Design Brief - REVISED

# 6310 Hazeldean Rd. Development

April 2024

## Review of UDRP's comments received on October 6th, 2022

CONCEPT SITE PLAN - PROPOSED IN FALL 2022

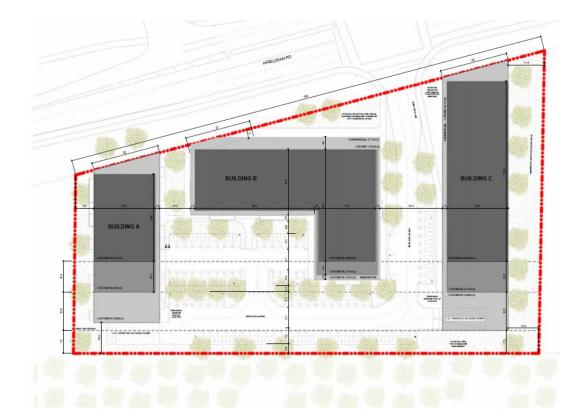
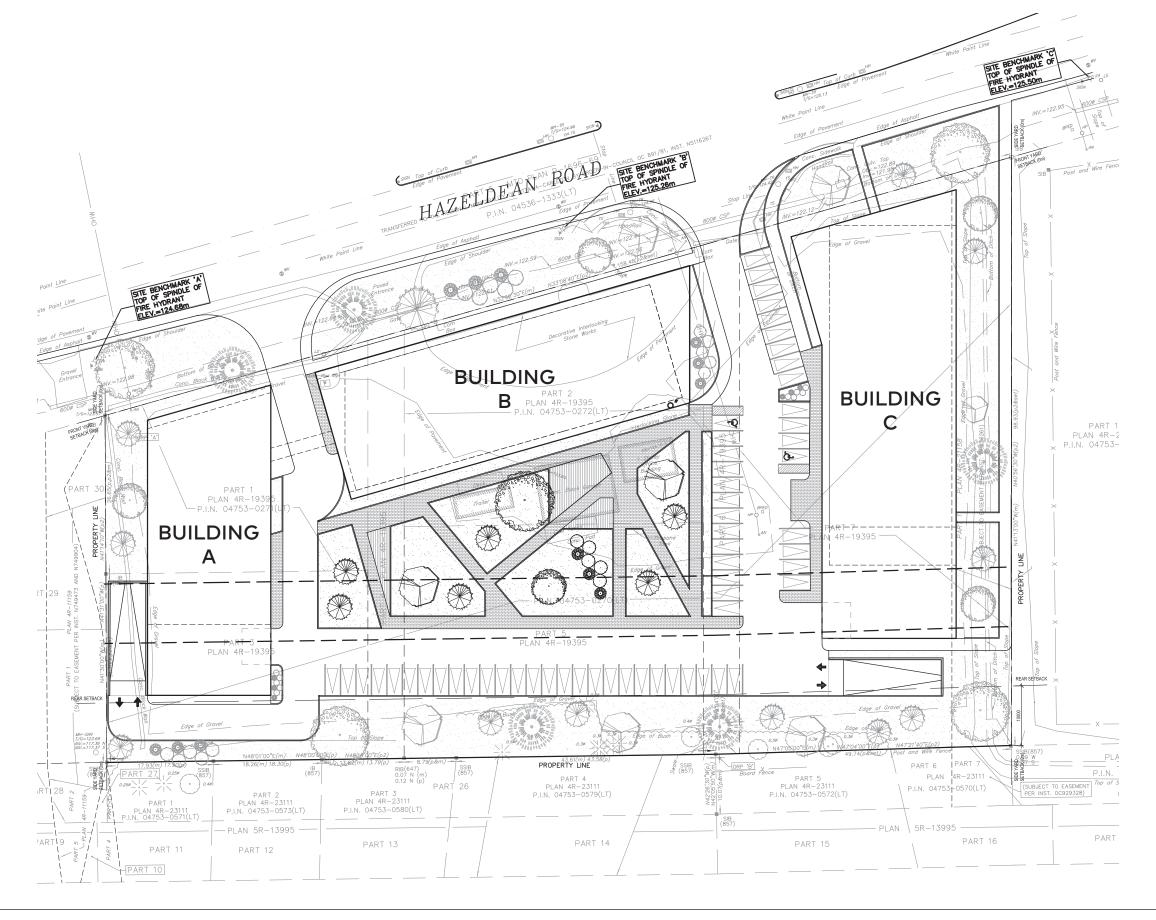
The Panel expressed disappointment with the current level of resolution of the architecture.

The Panel recommends the City not grant the changes to the setbacks as the site provides enough space to accommodate the buildings while maintaining the setbacks requirements.

The Panel recommends increasing the density on Hazeldean Road and reorienting Building B to parallel the street to create an urbanized corridor. Should the building be parallel to the street, the Panel recommends connecting Buildings A and B with glazed volume. Additionally, the proponent should consider elongating the building to eliminate the north-south wing since the inside corner units of an L-shaped building have with limited access to light.

The proponent should consider relocating the drop-off area underground on the north side of Building C to provide access to all three buildings. This would open up the layby space and allow for more greenery and reconfiguration of the parking layout.

The Panel questioned the appropriateness and amount of commercial space on the ground floor, given retail may not be viable. The space could be used for residential amenities.

The Panel believes the site's configuration is dominated by parking. The proponent should develop a strong pedestrian realm proposal that accommodates bicycle parking and has a high-quality landscape with outdoor amenities and a residential character.

The Panel has concerns with the scale and massing on the site as the buildings do not reflect the neighbourhood's character and only relate to each other. The Panel recommends the proponent study the area and its architecture to establish a language that complements the neighbourhood.

The Panel notes the ground floors configurations are repeated throughout the site, and the suite plans might do not reflect the siting or architecture of the individual buildings. The proponent should consider providing a high-quality amenity at grade, as the amount of space allocated for each suite is questionable.

The proponent should consider more variety on the facades and larger glazed openings and the introduction of large family units to break up the sameness of the buildings. The proponent should also consider adding more glazing with masonry at key corners to provide amination at the ground floor level.

The Panel believes Building C should have more articulation to break up the long façade.

The proponent should consider stepping and terracing the building toward the neighbourhood to provide a more significant transition and greenery at the rear

The Panel has concerns with the parking at the rear, given the possibility of headlights spilling into neighbours' yards. The parking does not allow for an outdoor amenity area due to the limited open space. The proponent should consider eliminating parking at the rear or designing the open spaces first, before laying out the parking.

There is an opportunity to add a bosque of trees and have a wrap-around landscape adjacent to the townhouses to create a strong landscape design and to strengthen the existing buffer.

The proponent should focus on site sustainability by implementing stormwater management and providing opportunities within the landscape to integrate utilities.

Acknowledged, a new updated concept has been prepared that includes a strong contemporary architectural expression. This new proposal includes a stronger ground plane experience with ground floor accessible units and strong active entrances for the two buildings proposed.

Agree, the new concept provides a stronger presence to Hazeldean while providing a strong transition to the neighbouring properties to the south. Though a future ROW is considered in the site plan placement of the buildings, we anticipated that this new street scape will eventually include for stronger pedestrian sidewalks, a bike path and significant green space that is included in this proposal.

Acknowledged, the team has included Figurr Architects who have prepared a more detailed exploration of the development, including enhanced urban design experiences, building massings and aesthetics, as well as how the buildings reflect the existing urban conditions along Hazeldean Rd. and the neighbouring properties.

Acknowledged, responded to in previous comment

Acknowledged, the site planning in the new proposal respects all required setbacks.

Acknowledged, a new proposal by Figurr Architects new proposes a two building solution with a strong street face along Hazeldean. Massings and heights have been carefully developed to contribute to a strong main street façade, an appropriate transition to neighboring properties, as well as considering sun and shading of the massing against this and other neighboring sites.

Acknowledged, a new two building proposal has been prepared with a stronger centralized drop off for both buildings under building 1. Parking has now been concentrated within a two storey parkade structure (and u/g garage) that has been clad with light coloured panels and vegetated screens.

Acknowledged, commercial no longer part of new updated proposal.

Acknowledged, at grade parking has been greatly minimized to provide mostly for visitors. A new 2 storey parkade (and u/g garage) will house remaining parking. A large amenity terrace will be located above the garage parkade.

Acknowledged, this new proposal has a stronger contemporary language. This area of the city does NOT have a specific and strong existing building language. The area is dominated by a mix match of suburban single family homes, industrial lands and typical suburban commercial strip centres. We do not believe that these are great examples to draw from and believe that the new concept – through thoughtful massing, proper transitions, and enhanced green buffer areas - provides a strong refined aesthetic that actually responds to enhancing urban planes.

Acknowledged, the new proposal has been properly explored to include proper ground floor programming for these types of buildings. Programs have been located to enhance the public realm with clean open and active entrances and amenity areas along Hazeldean. Bike rooms, move-in rooms and access to other supportive programs have been properly located to further support the concept.

Acknowledged, the concept attempts to address these concerns with a strong contemporary design as also previously mentioned in past comments. Larger units will be part of the project but a final unit typology will be part of a future Site Plan Control submission.

Acknowledged, please see new proposed concept that has a two building solution with varying setbacks and material explorations.

Acknowledged, new concept has been primarily developed by exploring that major aspect along the neighbouring properties.

Acknowledged, a new enclosed parking structure integrated with the buildings has been proposed. This greatly reduces the at grade parking. Project will ensure a minimum fence line and significant 10m green buffer zone between the rear lot lines and any building or parking area.

Acknowledged, please see new concept that greatly increases the use of green landscaping and significant buffer zones.

Acknowledged, as the concept now evolves, this will be part of the proposed project.
